ROYAL AUTOMOBILE CLUB

Form of recognition in accordance with appendix J to the International Sporting Code of the
FEDERATION INTERNATIONALE DE L'AUTOMOBILE

Cylinder-capacity 1601 cm.³ 97.55 in.³
 Model ESCORT RS 1600
 Manufacturer FORD
 Manufacturer FORD
 Serial No. of chassis/body BB49KL 11059
 Manufacturer FORD
 Serial No. of engine HE 1001
 Manufacturer FORD
 Recognition is valid from 1st October 1970
 List 1970/10
 The manufacturing of the model described in this recognition form started on 11 January 1970
 and the minimum production of 1000 identical cars, in accordance with the specifications of
 this form was reached on 1st September 1970

Manufacturer FORD
Model Escort RS 1600
F.I.A. Recognition No. 1605/1/1V
Amendment No. 1

Five-speed Gearbox ZF
Part No: CD 70/4

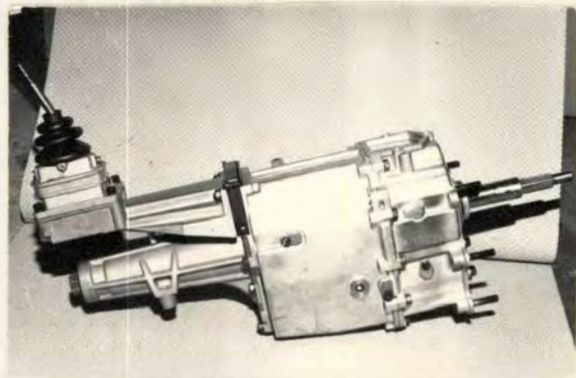
Manual type make ZF

Number of gearbox ratios forward (5) five

Synchronized forward ratios (5) five

Location of gear shift, remote control floor control

Overdrive: A gear ratio for the 5th position gives
overdrive ratio if desired.

Equipment for Rear Brake Conversion

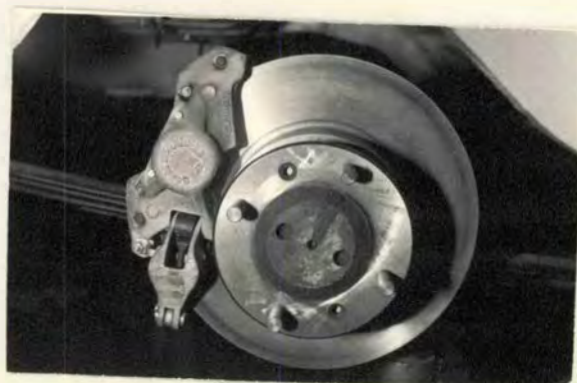
Includes Caliper and mounting bracket, disc and mounting collar

Part No. CD 70/50 Increases rear track by 0.5 ins.

100.	Outside Dia. of disc	10 inches	5.25
101.	Thickness of disc		.375 inches
102.	Length of brake lining		2.25 inches
103.	Width of brake lining		1.562
104.	Number of pads per brake		2 (+ 2 for handbrake)
105.	Total area per brake		7 sq. ins. of pad 113 sq. ins. of disc

CRANKSHAFT - Steel

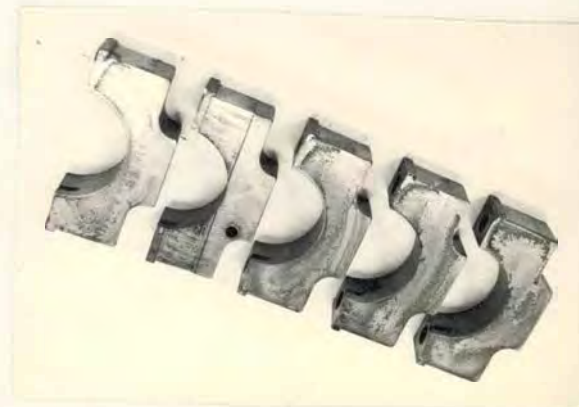
∅ bearings & stroke = unchanged -

- 147 Crankshaft Stamped
- 148 Type of Crankshaft Integral
Forged with balance weights
- 149 No. of main bearings. (Five 5.)
- 162 Crankshaft weight

CONNECTING ROD - Steel

MAIN BEARING CAP - Steel

150 Material of bearing caps, steel.

STEEL FLYWHEEL

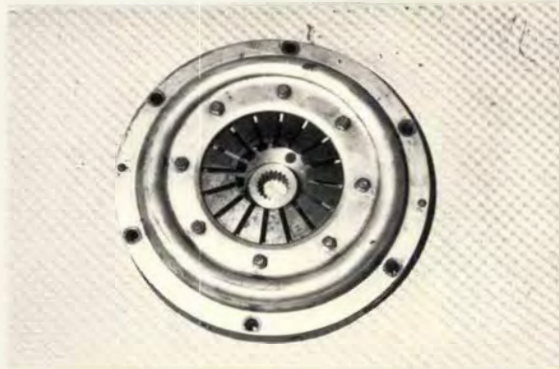
160 Weight of flywheel clean :
5.5 kgs. 12 lbs

TWIN PLATE CLUTCH

260 Type of clutch Diaphragm
261 Number of plates (2) Two
262 Dia of clutch plates
7.25 inches
263 Dia of linings inside:
5.25 inches
outside: 7.25 inches

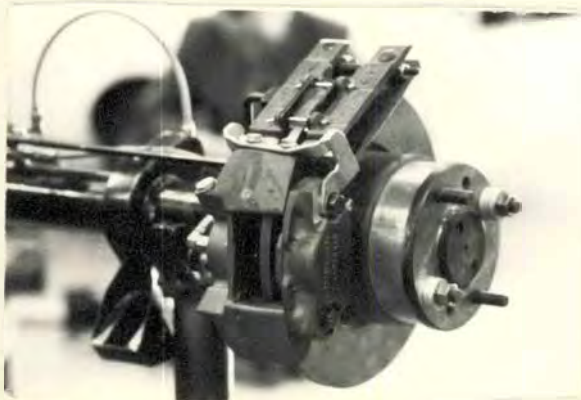
No.	Reference No.
	Group II Variant
	Brakes of a different type and dimension with larger hubs and spindles.
	Part no. OP 2213 FV 28
	Outside dia of disc 10 ins
	Thickness of disc 0.375 ins
	Length of pad 2.75 ins
	Width of pad 2.12 ins

Evolution in Production

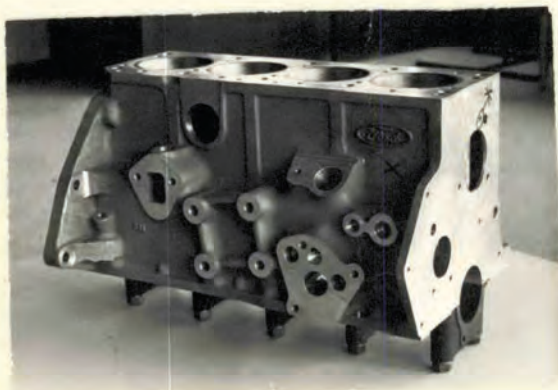
After 1st August 1972, cylinder block No.H711F 6K006AA will be replaced by cylinder block No.H721F 6010AA in every vehicle produced after this date.

137 Material of block : ALUMINIUM ALLOY

138 Material of sleeve : STEEL

Weight of Block 45lbs 20.5 kilos.

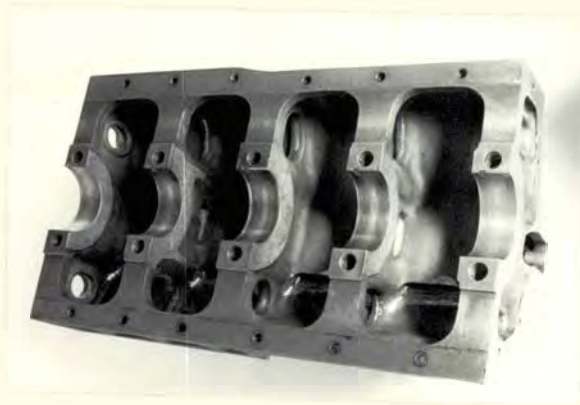
No.	Reference No.
	Group 2 variant Alternative sump pan incorporating bearing caps See photograph below
	Weight: 14lbs Material: Alluminium Alloy

Photo 1

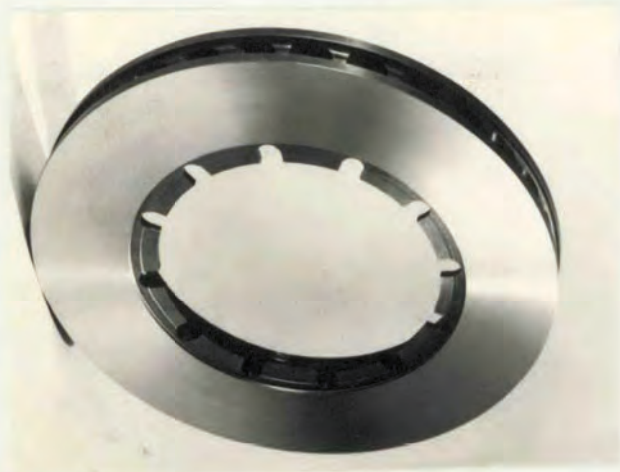
Ventilated brake disc front

Part No 90 51671/2

Outside dia: 11,67 ins

Photo 2

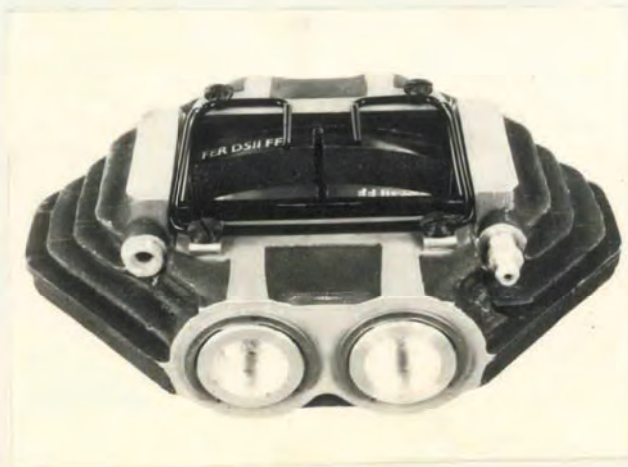
ventilated brake disc front

Part No 9050 981 A/B

outside dia: 11,97 ins

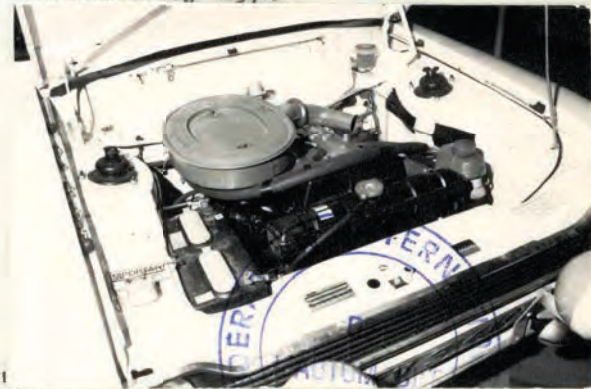
No.	Reference No.		
		Evolution in production.	Engine size increased by 15%.
133	86.88mm	3.42lin	
134	76.62mm	3.056in	
135	460.2 cm ³	28.08in ³	
136	1846.8 cm ³	112.3in ³	
210	One		
211	Down draught		
212	Weber		
213	DGAV		
214	Two		
215	32mm and 36mm	(1.259" and 1.417"	
216	Prim. 26mm	(1.023")	
	Sec. 27mm	(1.063")	
250	122 BHP - DIN

Car badging changed to read RS1800 to remain in line with Corporate Policy. Specification remains as RS1600 with any preceding evolutionary changes, and including all options.

Photo 4

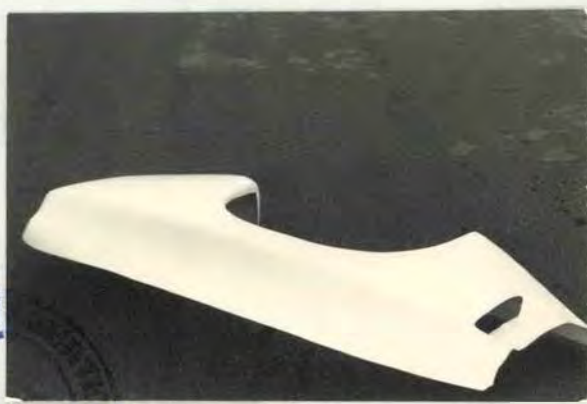
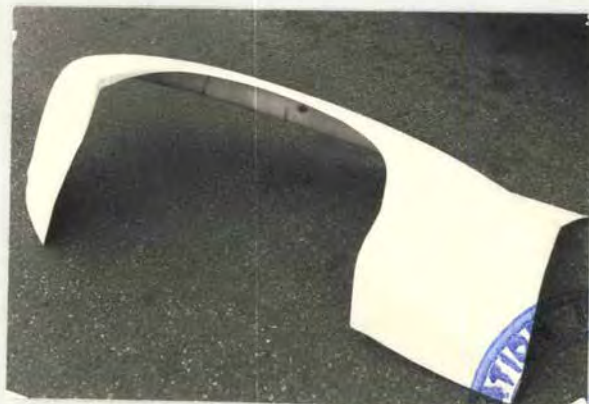
Wing extension increasing the widths of the car by not more than 5cm on each side.

FCO 580 Front
 FCO 581 Rear

Photo A

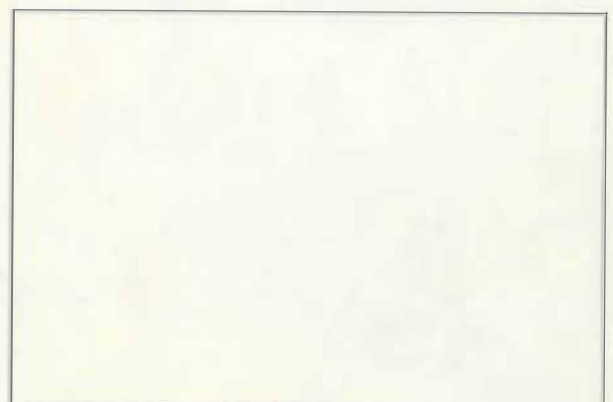
No.	Reference No.
	Rear caliper of different type incorporating handbrake mechanism.
	Length of Pad = 60. mm (2.375") Width of Pad = 36.5mm (1.437") Area of Pads = 23.9 (3.71 sq.in.)
	- Photo A
	Rear caliper of different type.
	Length of Pad = 95 mm (3.7") Width of Pad = 48 mm (1.89") Area of Pads = 85.5 sq. cm. (13.25 sq. in)
	- Photo B
	Revised compression strut for front suspension.
	- Photo C
